*Kane County Division of Transportation
Longmeadow Parkway Section C1 – Contract 63955*

Addendum #1 – September 25, 2018

Addendum #1, as issued by the Kane County Division of Transportation on September 25, 2018, includes the following revisions and clarifications:

F.A.U. RTE.	SECTION	COUNTY	TOTAL SHEETS	SHEET NO.
2298	13-00215-20-BR	KANE	239	19
CONTRACT NO. 63955				
ILLINOIS FED. AID PROJECT

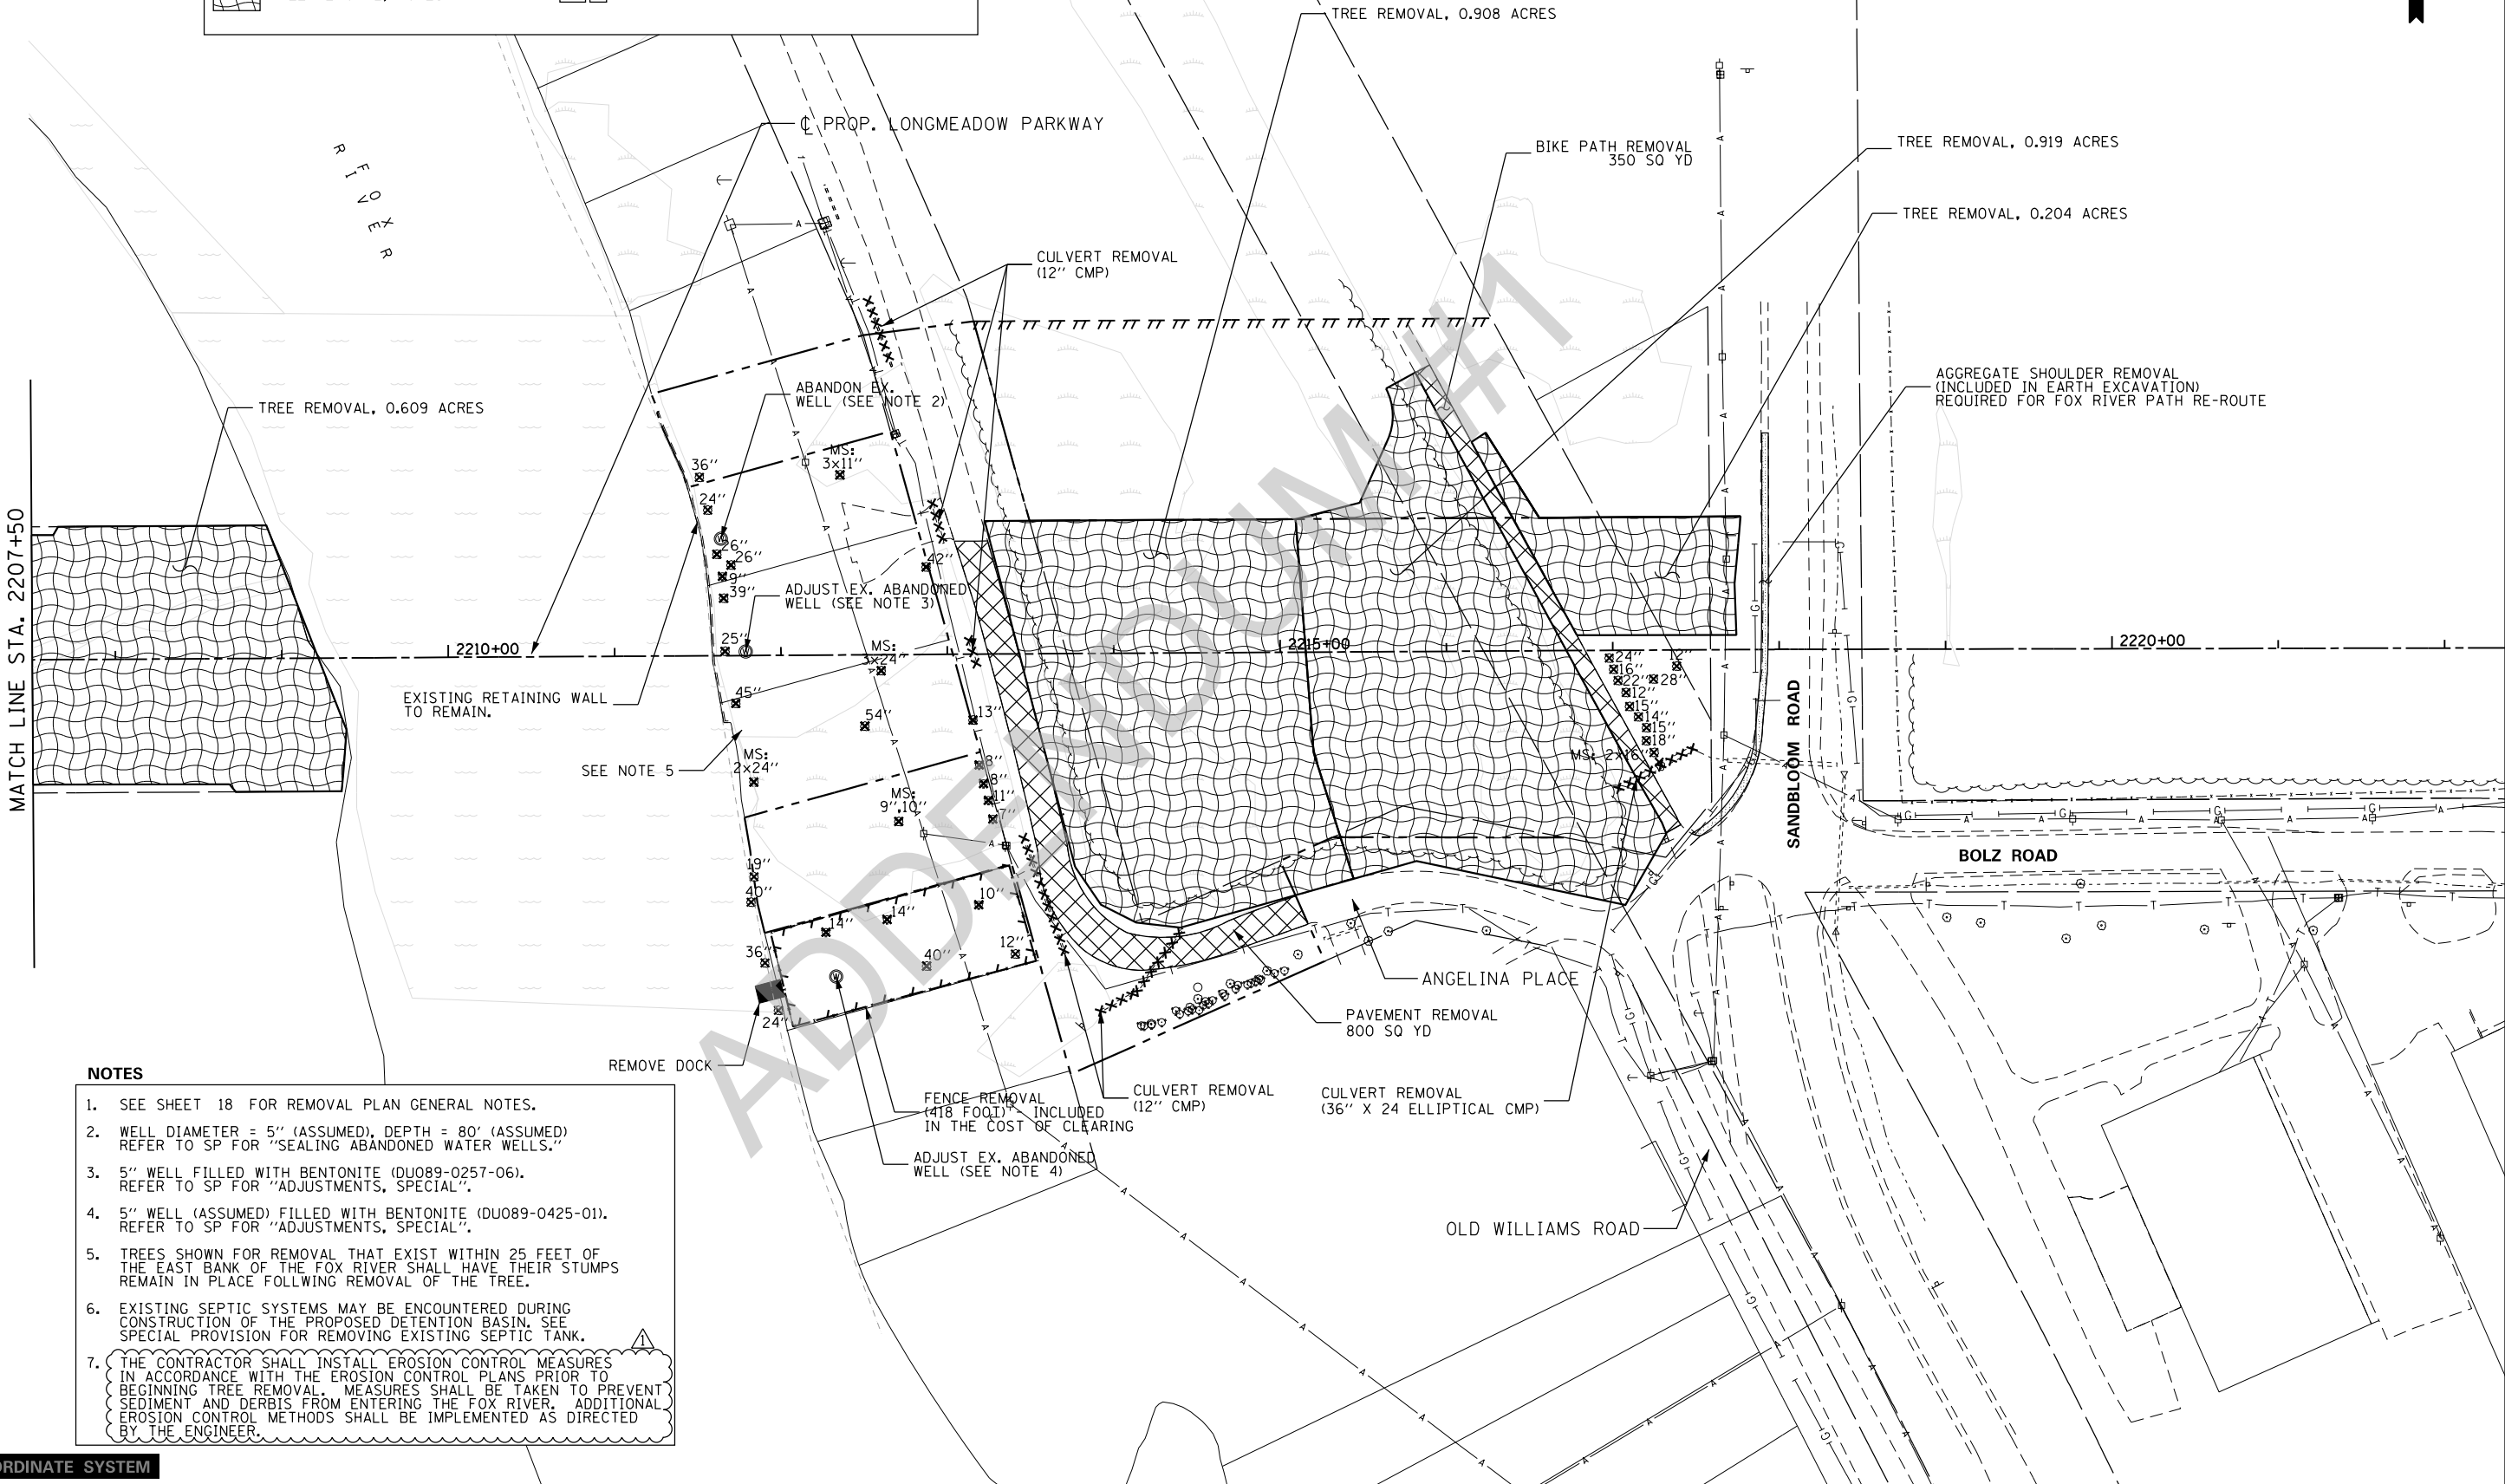
- Sheet 006 - Revised pay item 52200020, TEMP SOIL RETEN SYSTM from 3,040 Sq. Ft. to 4,580 Sq. Ft.
- Sheets 018 & 019 – Included note that requires erosion control measures to be installed prior to beginning tree removal operations.

7. THE CONTRACTOR SHALL INSTALL EROSION CONTROL MEASURES IN ACCORDANCE WITH THE EROSION CONTROL PLANS PRIOR TO BEGINNING TREE REMOVAL. MEASURES SHALL BE TAKEN TO PREVENT SEDIMENT AND DERBIS FROM ENTERING THE FOX RIVER. ADDITIONAL EROSION CONTROL METHODS SHALL BE IMPLEMENTED AS DIRECTED BY THE ENGINEER.

F.A.U. RTE.	SECTION	COUNTY	TOTAL SHEETS	SHEET NO.
2298	13-00215-20-BR	KANE	239	35
CONTRACT NO. 63955				
ILLINOIS FED. AID PROJECT

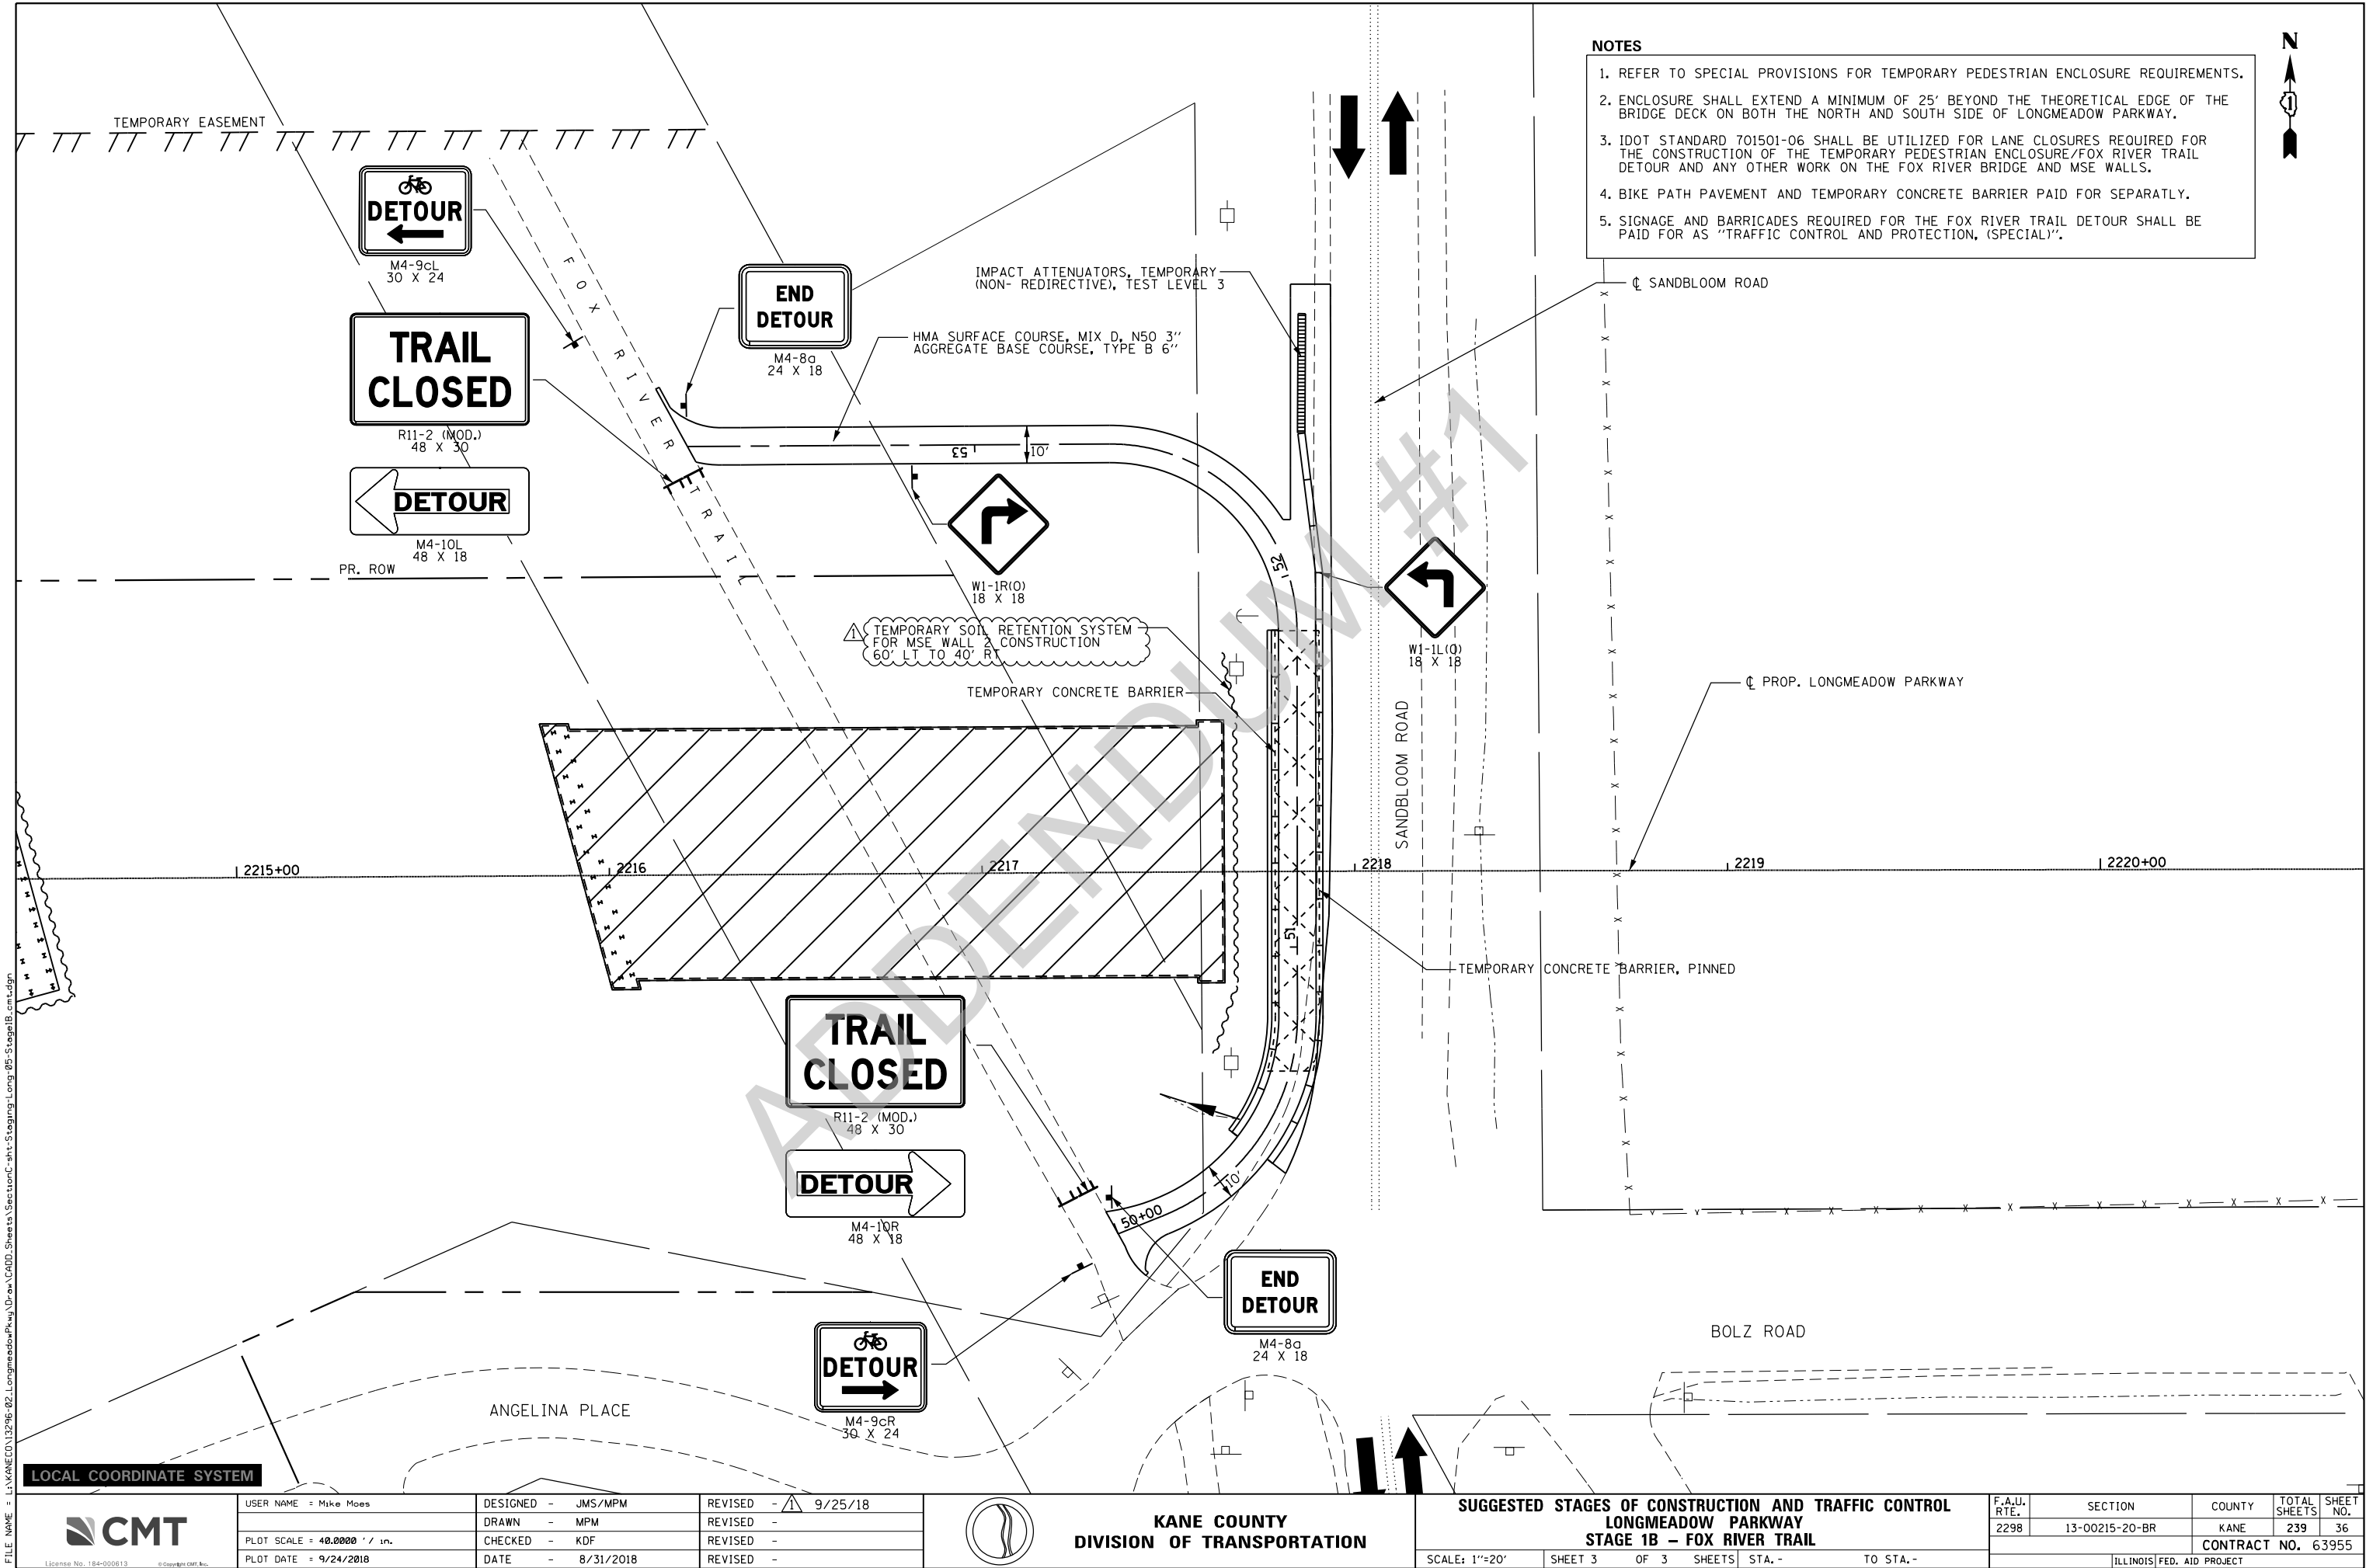
- Sheet 035 – Included Temporary Soil Retention System between MSE wall 2 and the Temporary Pedestrian Enclosure.
- Sheet 036 – Included Temporary Soil Retention System between MSE wall 2 and the Temporary Pedestrian Enclosure.

TEMPORARY
PEDESTRIAN
ENCLOSURETEMPORARY SOIL RETENTION SYSTEM
2207+20 TO 2207+60TEMPORARY SOIL RETENTION SYSTEM
2207+00 TO 2208+00TEMPORARY SOIL RETENTION SYSTEM
FOR MSE WALL 2 CONSTRUCTION
60' LT TO 40' RT

F.A.U. RTE.	SECTION	COUNTY	TOTAL SHEETS	SHEET NO.
2298	13-00215-20-BR	KANE	239	185
CONTRACT NO. 63955				
ILLINOIS FED. AID PROJECT

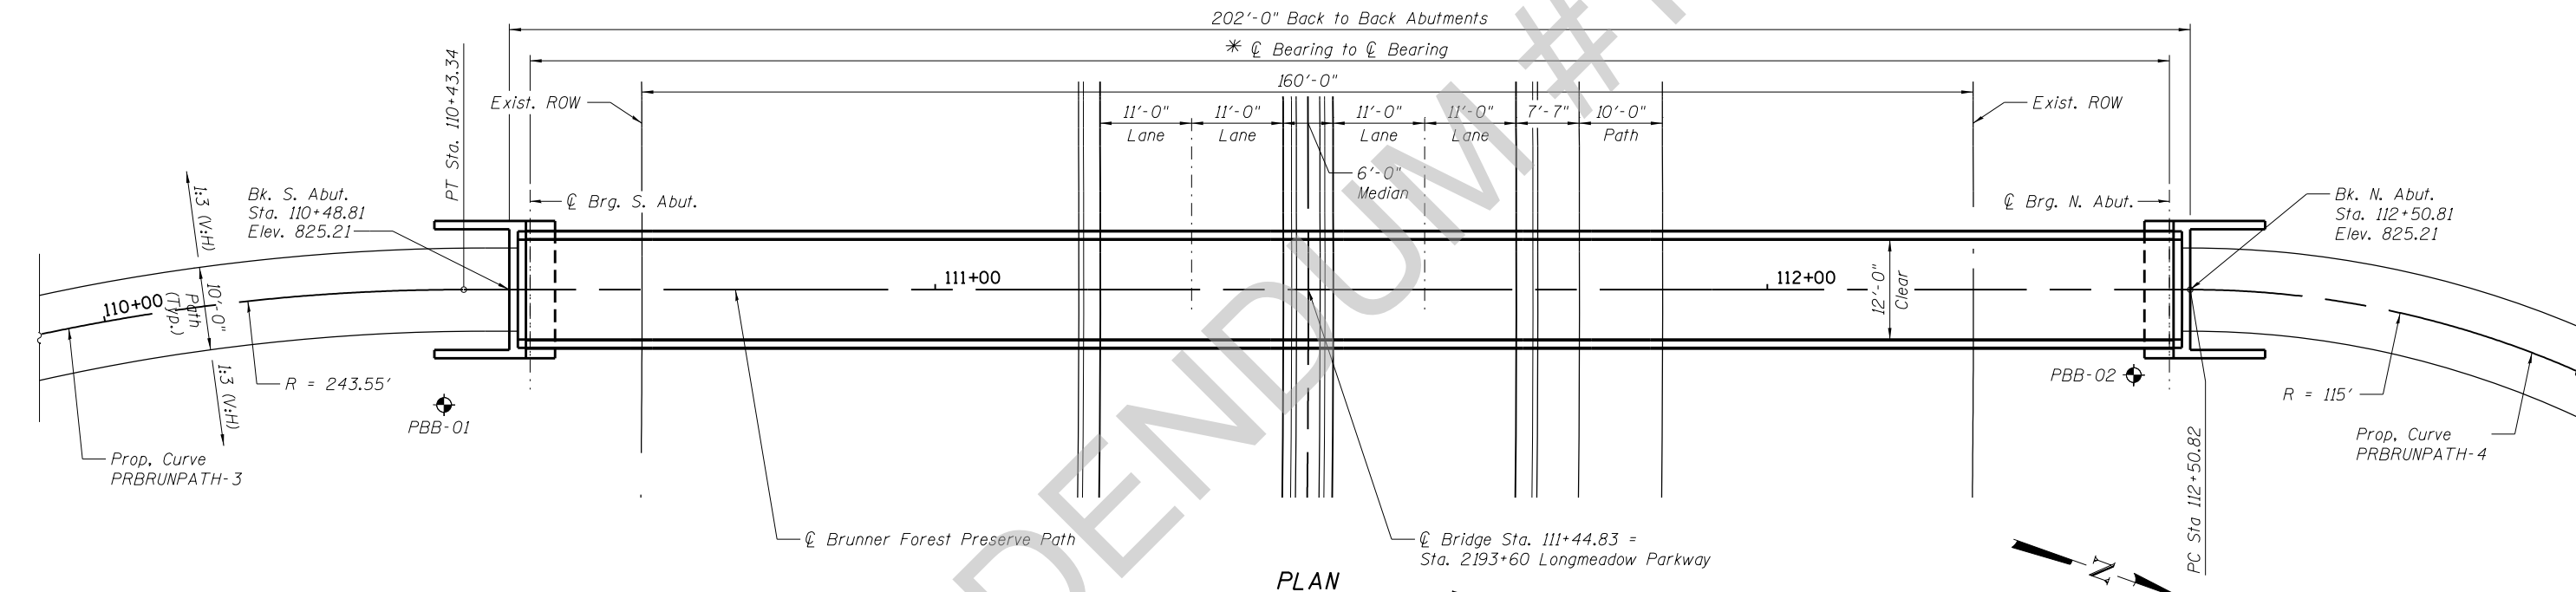
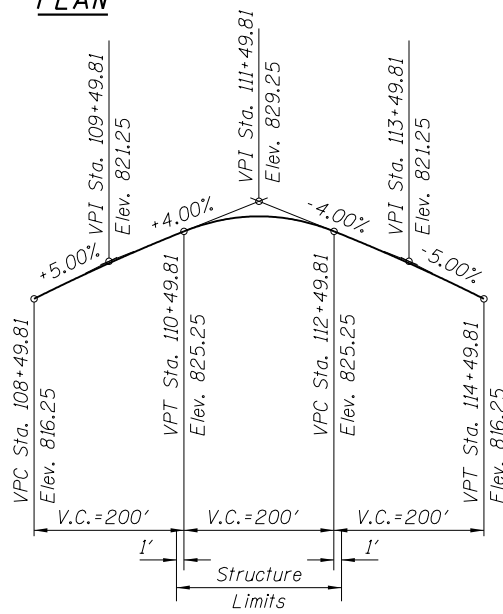
- Sheet 158 – Revised pre-approved manufacturer of Form Liner Textured Surface to Custom Rock Formliner, Pattern Number 1208, Pattern Name: Drystack.
- Sheet 185 – Included design stress and steel type for Pedestrian Truss Superstructure; $f_y = 50,000$ psi (M270 Grade 50W) - Truss

$f'_c = 3,500$ psi
 $f_y = 60,000$ psi (Reinf.)
 $f_y = 50,000$ psi (M270 Grade 50W) - Truss

F.A.U. RTE.	SECTION	COUNTY	TOTAL SHEETS	SHEET NO.
2298	13-00215-20-BR	KANE	239	186
CONTRACT NO. 63955				
ILLINOIS FED. AID PROJECT

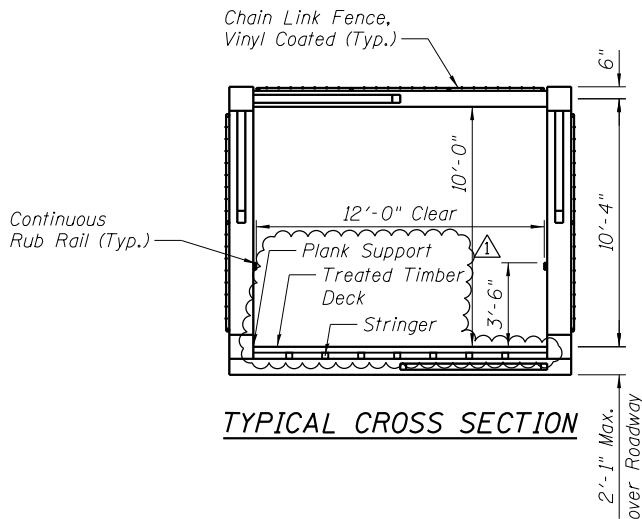
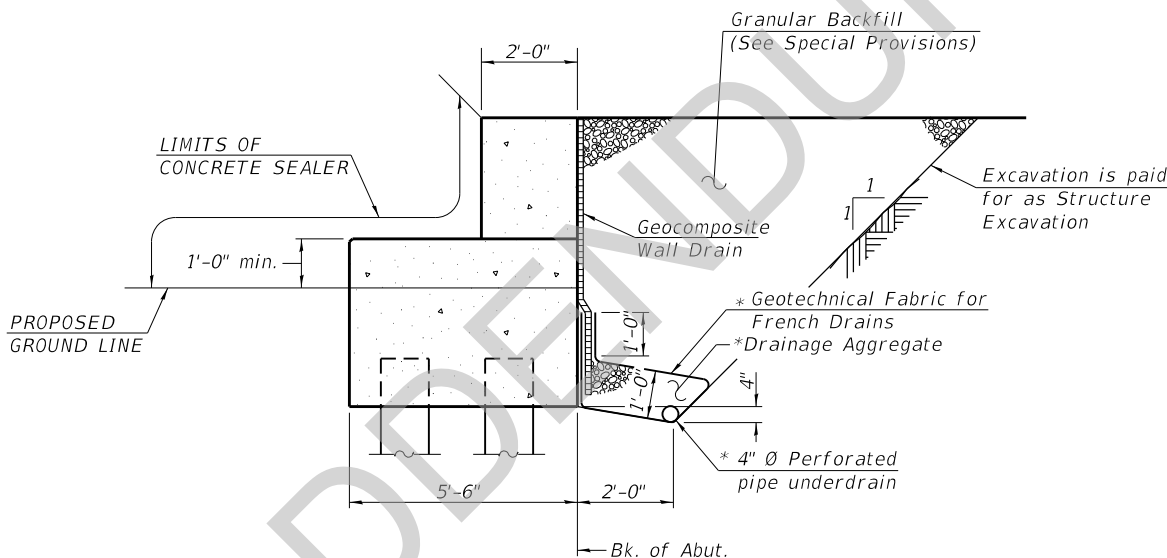
- Sheet 186
 - Revised typical cross section to show stringers under deck
 - Added notes under “Truss Manufacturer”:
 - Bridge Decking shall be nominal 3” thick select structural timber in accordance with Section 1007.03 of the IDOT Standard Specifications. $F_{b0} = 1.40$ ksi minimum. Maximum stringer spacing 1’-8”.

- The truss manufacturer shall design connection of timber deck to stringers and submit sealed calculations with shop drawings.

The truss manufacturer shall design and furnish all truss bearing anchor bolts. Bridge decking shall be nominal 3" thick select structural Timber in accordance with Section 1007.03 of IDOT Standard Specifications. Fbo 1.40 ksi minimum. Maximum stringer spacing 1'-8".

The truss manufacturer shall design connection of timber deck to stringers and submit sealed calculations with shop drawings.
